TECHNICAL NOTE

HUNTS LANE, DESFORD

project number: ADC3964			report reference: ADC3964-RP-D	
version	date	author	reviewer	comments
1	18/02/2026	Jamie Cassie	Tim Cooke	First issue

- 1.1 This Technical Note has been produced to respond to the comments made by the local highway authority, Leicestershire County Council (LCC), on a planning application for the development of land to the north of Hunts Lane in Desford for up to 75 dwellings.

Figure 1 – sketch layout of B582/Main Street junction improvement

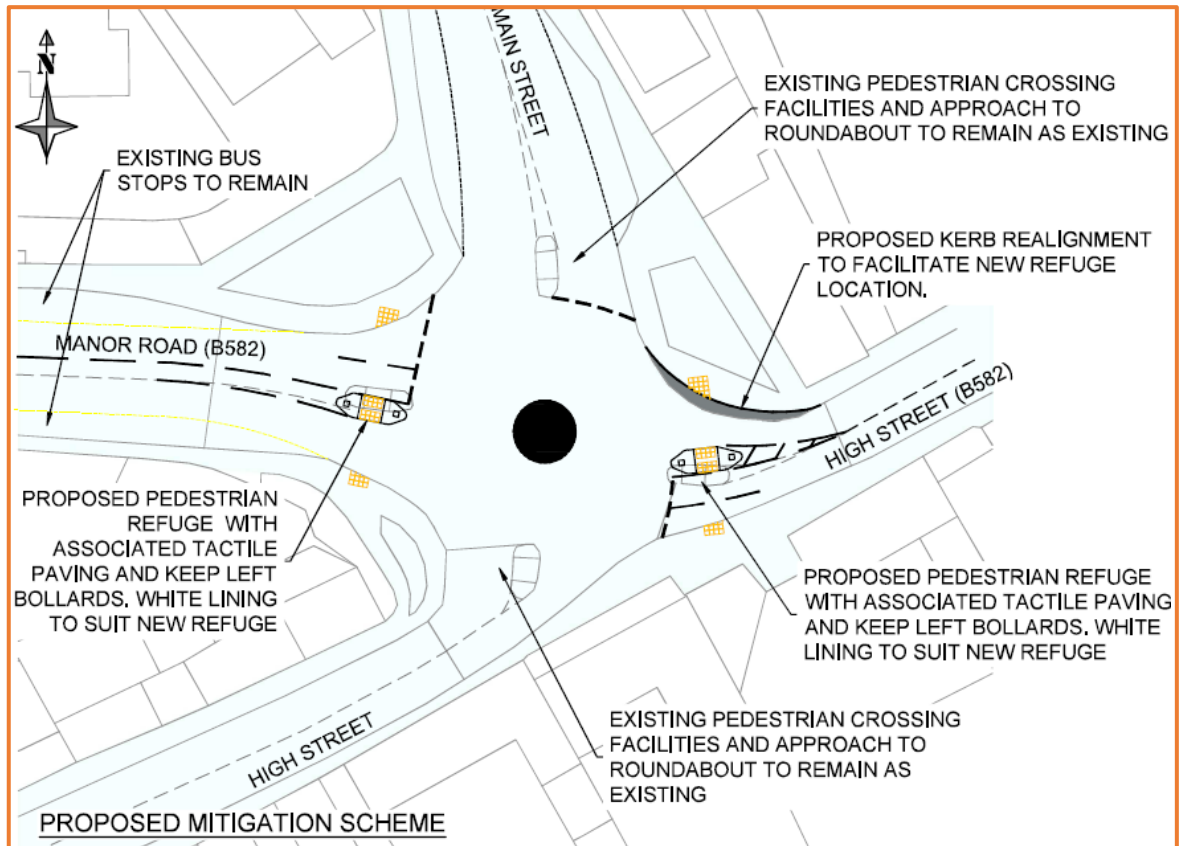
The above shows a maximum RFC of 1.02 in the future assessment year scenario, the Applicant should therefore consider mitigation to offset the impact of the development. The LHA conditioned, under application 24/01061/OUT, that a junction capacity improvement scheme at this junction was provided, alongside a Stage 1 Road Safety Audit so a similar scheme is likely to be acceptable.

2.7 The proposed improvement scheme put forward for application 24/01061/OUT is shown overleaf in **Figure 1**, with the revised capacity assessment for the 2030 Do Something (with development) scenario contained in **Appendix B** and summarised in the table overleaf.

2.8 Comparison of the results above with those predicted for the 2030 Do Minimum (no development) scenario in the original TA (replicated below for completeness) indicate that the proposed scheme would provide effective mitigation during the morning peak hour, together with a nil detriment mitigation in the evening peak hour.

2.9 In view of the above, it can be seen that a minor improvement scheme at the junction could provide mitigation. However, we would query whether mitigation at the junction is necessary to make the development acceptable, given that we consider that the cumulative residual impacts at the junction would not be severe, in accordance with the Framework.

Title: Proposed Site Access Layout

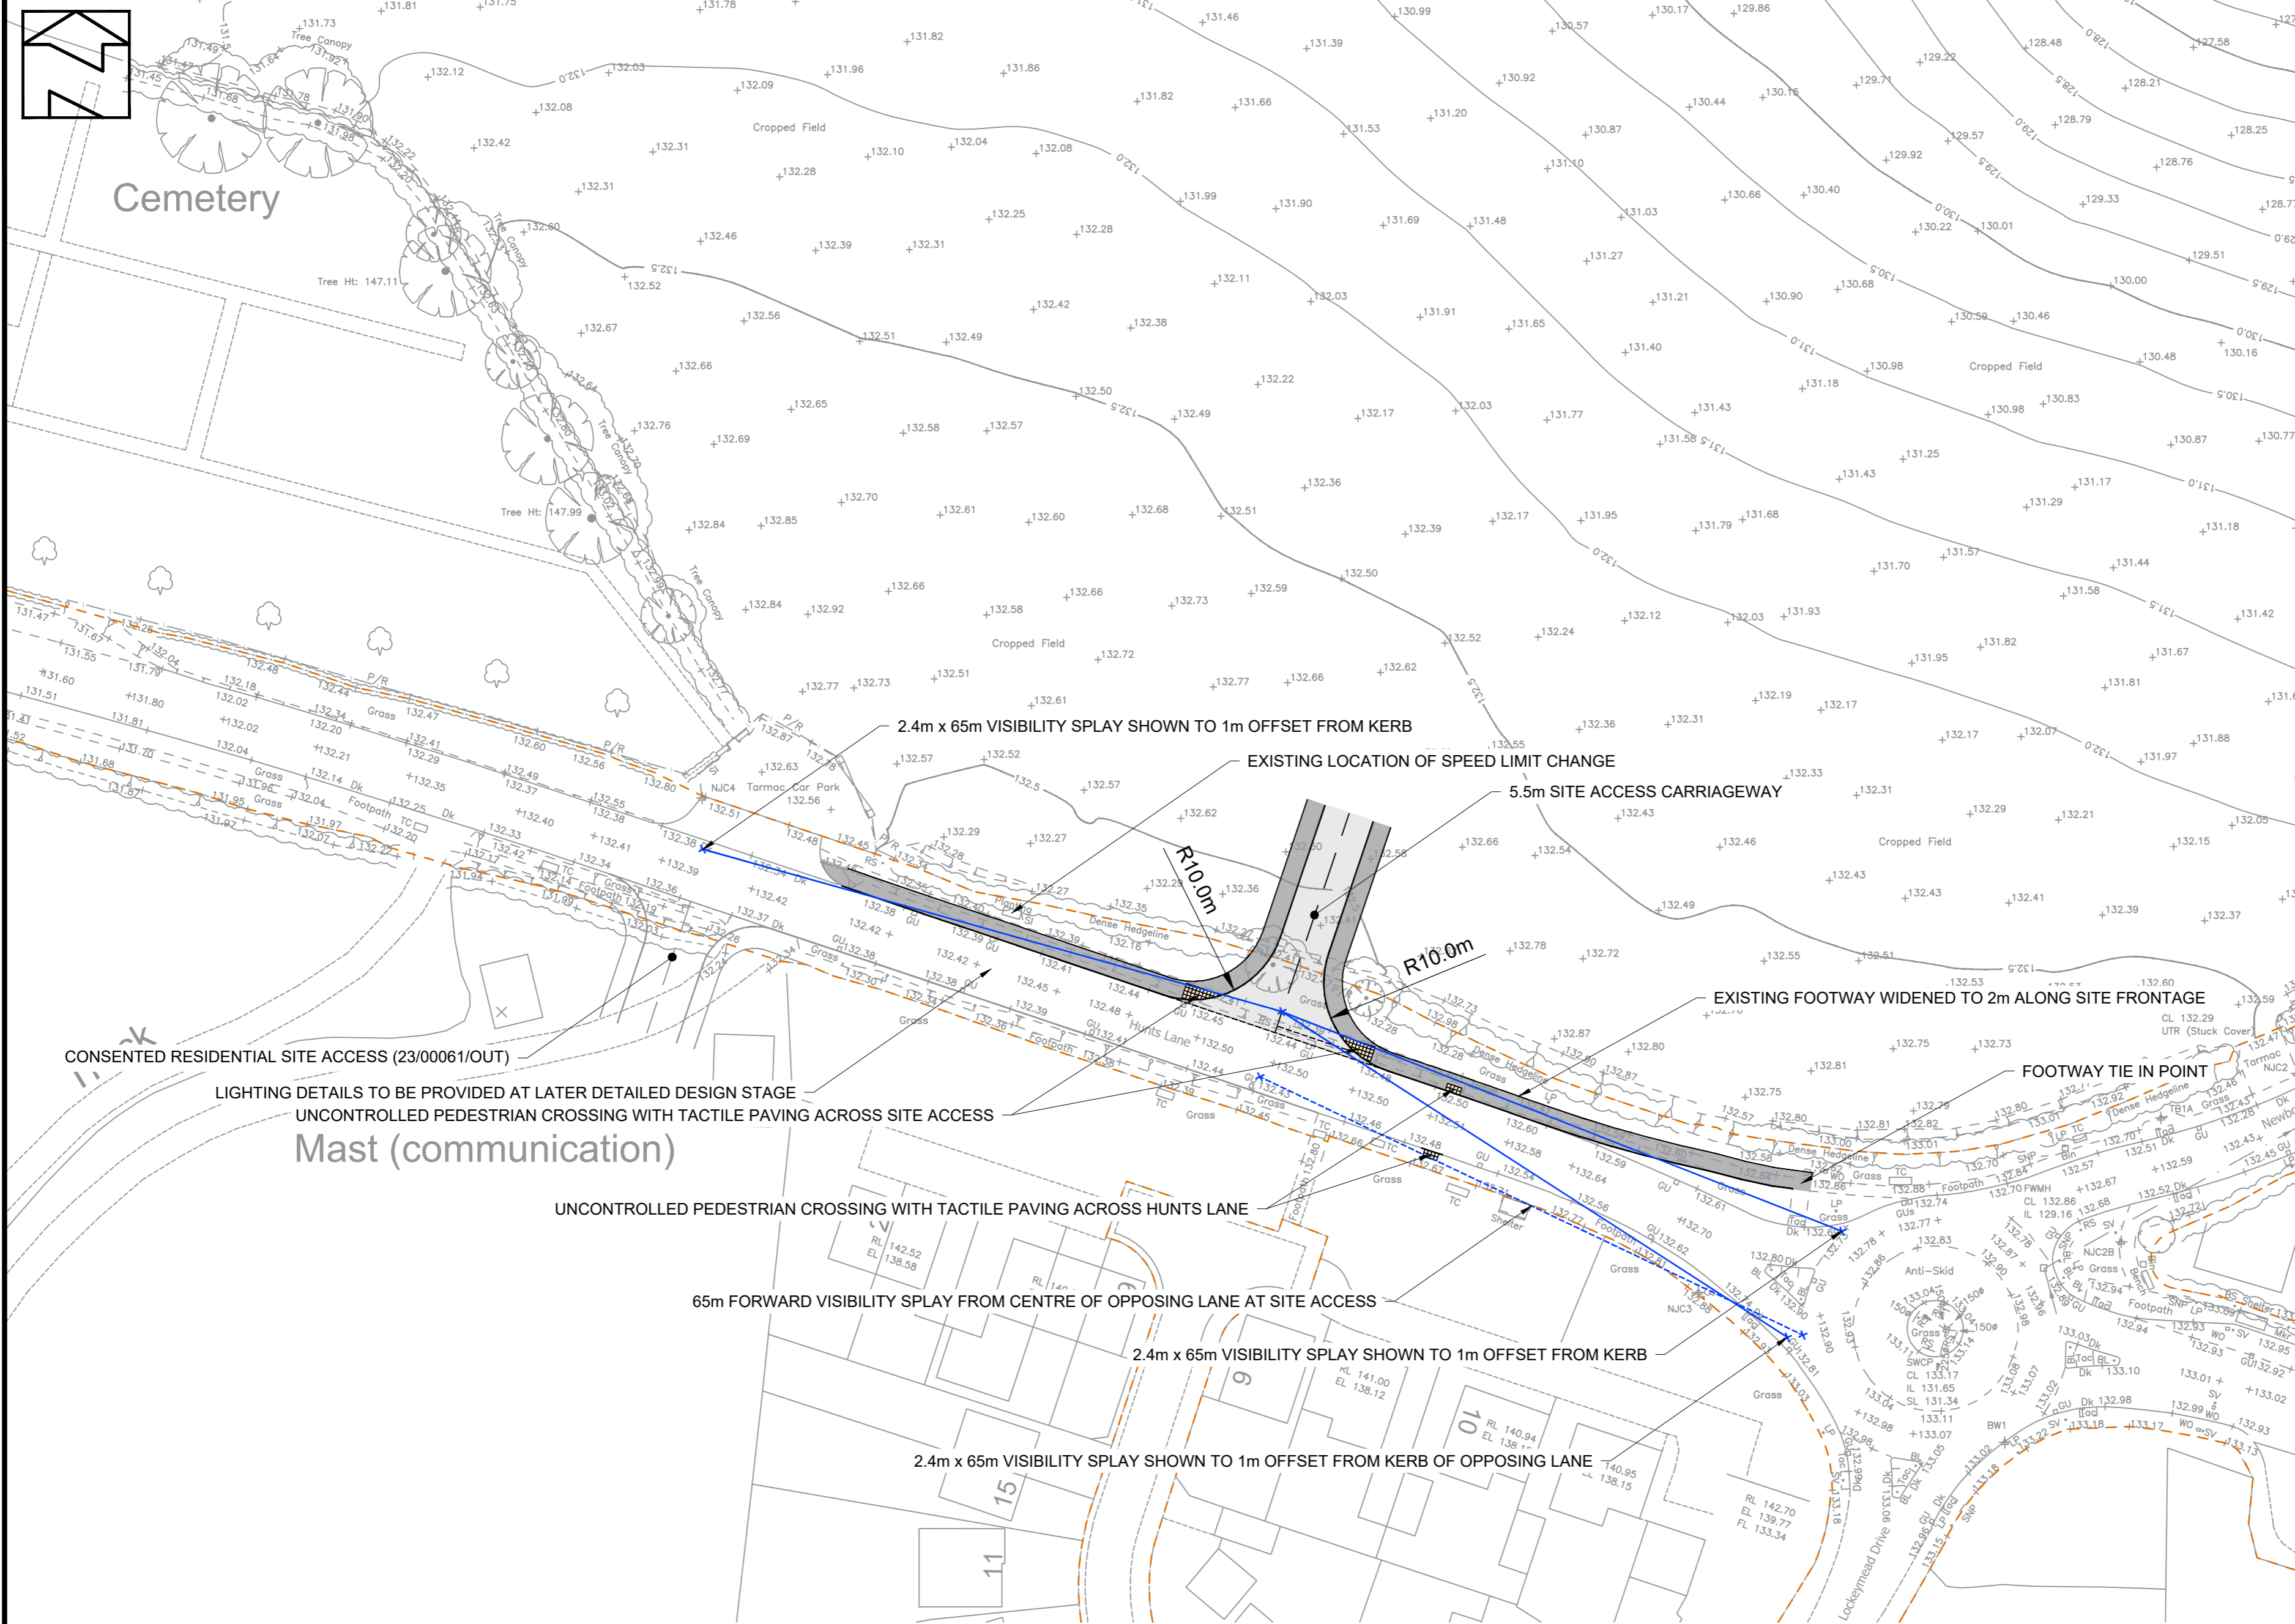
The LHA have reviewed drawing 3964 ADC HGN XX DR CH 0100 S1 Revision P03 (Proposed Access Layout), contained within the TA and note the following:

- The Applicant proposes a simple priority junction to serve this development; this aligns with the Design Manual for Roads and Bridges (DRRB) CD123 Figure 2.3.1.
- The width and radii of the junction geometry aligns with [Table 3](#) and [Table 9](#) of the LHDG.
- The proposed 2m wide footways are in accordance with [Table 18](#) of the LHDG.
- A stagger distance of 65m is to be provided between the proposed access and the consented access on the south side of Hunts Lane. This is in accordance with DMRB CD123 paragraph 2.23.

As to be in accordance with [Table 6](#) of the LHDG visibility splays of 2.4m by 65m would be required in both directions of the site access. This provision is demonstrated in drawing 3964 ADC HGN XX DR CH 0100 S1 Revision P03.

The Applicant should confirm that there is sufficient forward visibility for vehicles exiting the roundabout heading westbound on Hunts Lane, to a vehicle waiting to turn into the proposed access. The LHA are concerned that the existing bus shelter will obstruct the required visibility. If the bus shelter is required to be relocated to provide this visibility, this will be entirely at the Applicant's expense.

Proposed speed limit relocation

The Applicant proposes relocating the existing 30mph speed terminal approximately 95m to the west of Hunts Lane, this would not be supported by the LHA and should be removed from the proposals.

2.1 Whilst it is acknowledged that LCC appear to accept the principle of a simple priority T-junction access from Hunts Lane to serve the proposed development, a number of revisions to the site access design were requested. Accordingly, a revised junction design is shown on drawing **3964-ADC-HGN-XX-DR-CH-0100-S1-P04**. Relevant swept path assessments of the revised site access layout are shown on drawing **3964-ADC-HGN-XX-DR-CH-0130-S1-P03**. The revisions to the site access drawing are as follows:

- The proposed extension of the 30mph speed limit further west along Hunts Lane has been removed.
- Junction radii has been increased to 10m.
- Forward visibility of 65m for westbound vehicles to see right turning vehicles into site access has been shown on the drawing.

2.3 The 65m forward visibility splay for westbound vehicles to see right turning traffic into the site access indicates that the existing bus shelter to the south of the B582 Hunts Lane would not require relocating, although it is recommended that this is considered in further detail at the detailed design stage for the site access proposals. It should be noted that the extent of adopted public highway is such that a relocation of the bus shelter further west could be accommodated within the public highway if ultimately required.

Rev	Date	Description	Dr	Ch
P04	18.02.26	Updated following LHA comments	CD	JC
P03	11.11.25	Updated following Stage One RSA	CD	JC
P02	29.10.25	Second Issue to client team	CD	JC
P01	10.10.25	Preliminary Issue	CD	JC

Title: Proposed Site Access Layout
Swept Path Assessment

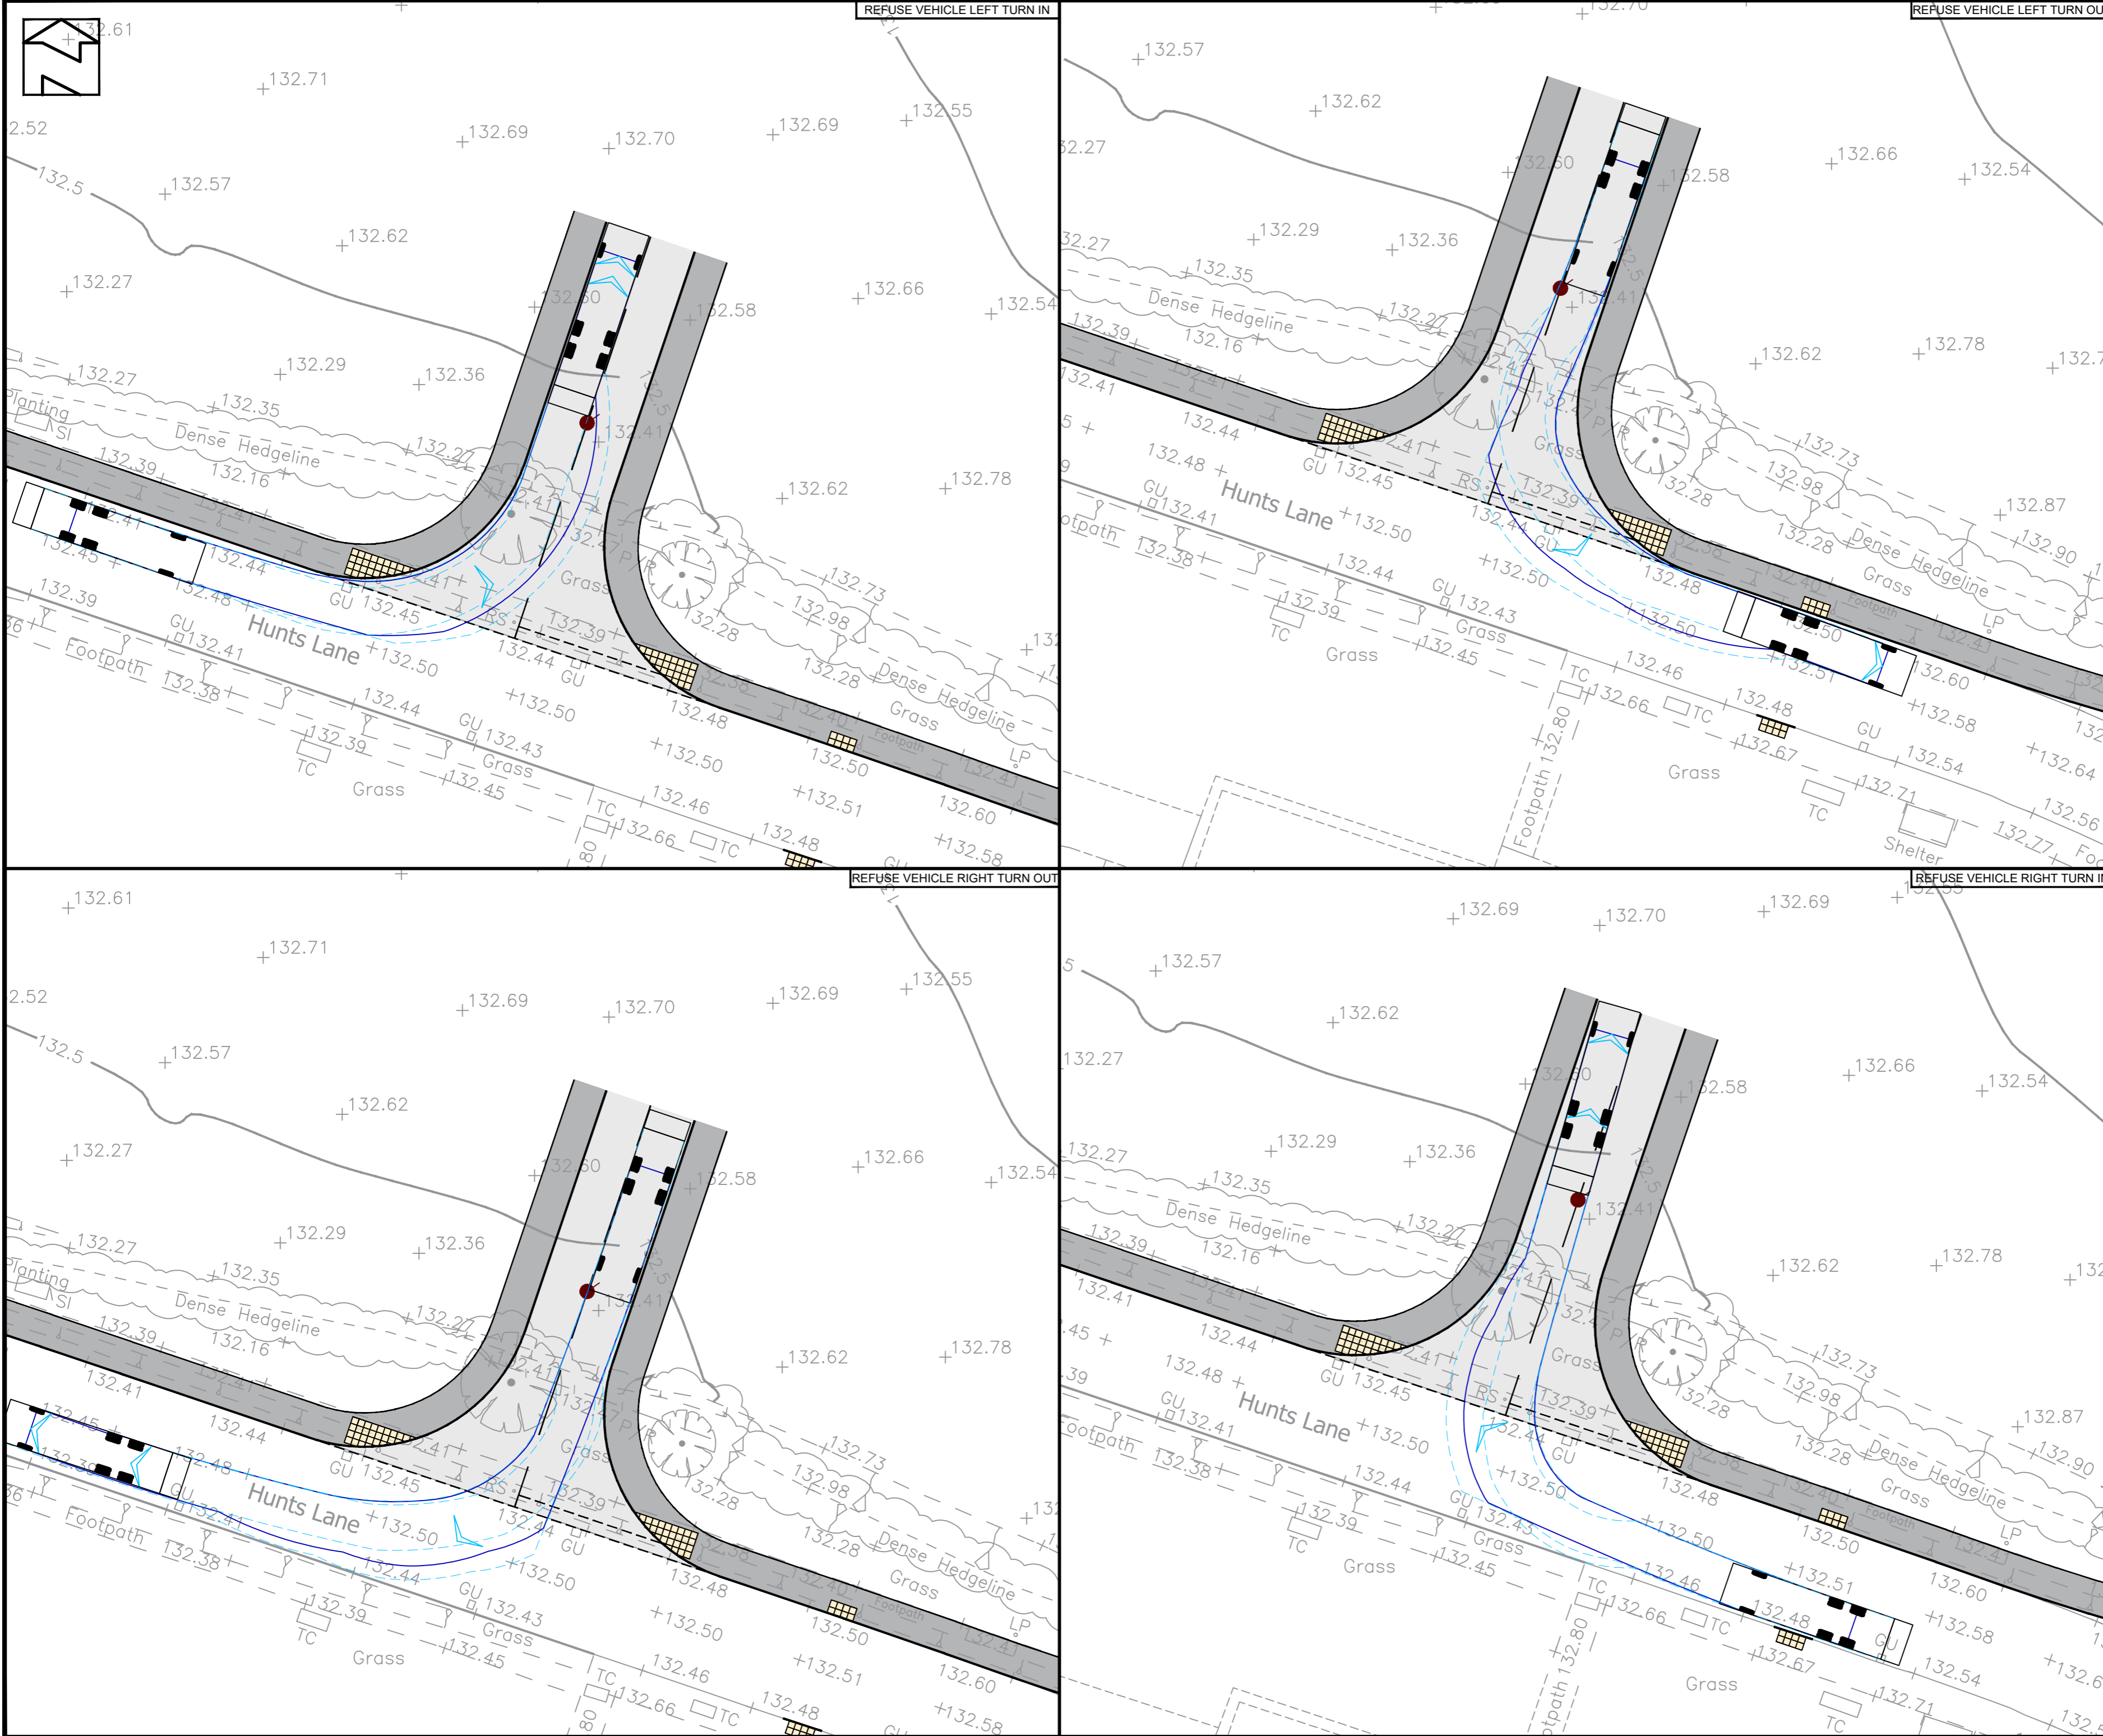
The LHA have reviewed drawing 3964 ADC HGN XX DR CH 0130 S1 Rev. P02 (Proposed Site Access Layout Swept Path Assessment), contained within the TA and note the following:

- A vehicle speed of 15kph should be used for swept-path analysis, a note should be added to the drawing to confirm this.
- The left turn in manoeuvre shows the vehicle requiring the entire width of the access road to perform the turn, which could result in collisions with oncoming vehicles exiting the development.
- The left turn in manoeuvre also shows the vehicle body overrunning into the opposite side of the carriageway on Hunts Lane. This could result in collisions with oncoming vehicles heading westbound on Hunts Lane or require the left turning vehicle to wait for oncoming vehicles to pass before performing the turning manoeuvre, leading to additional congestion on Hunts Lane.

- The left turn out manoeuvre shows the rear of the vehicle overrunning into the opposite side of the development road carriageway, which could result in collisions with oncoming vehicles entering the development.
- The right turn out manoeuvre shows the vehicle driving over the centre line of the access road to perform the turn, which could result in collisions with vehicles entering the development from the west.
- The right turn out manoeuvre shows the vehicle driving over the centre line of the access road to perform the turn, which could result in collisions with vehicles entering the development from the west.

2.2 The revised swept path assessments indicate that the increased junction radii of 10m is appropriate to accommodate relevant turning movements (and is greater than LCC minimum radii requirements). It should also be noted that 10m junction radii accords with the DMRB document CD123 'Geometric design of at-grade priority and signal-controlled junctions.'

Rev	Date	Description	Dr	Ch
P03	18.02.26	Updated following LHA comments	CD	JC
P02	11.11.25	Updated following Stage One RSA	CD	JC
P01	03.11.25	Preliminary Issue	CD	JC
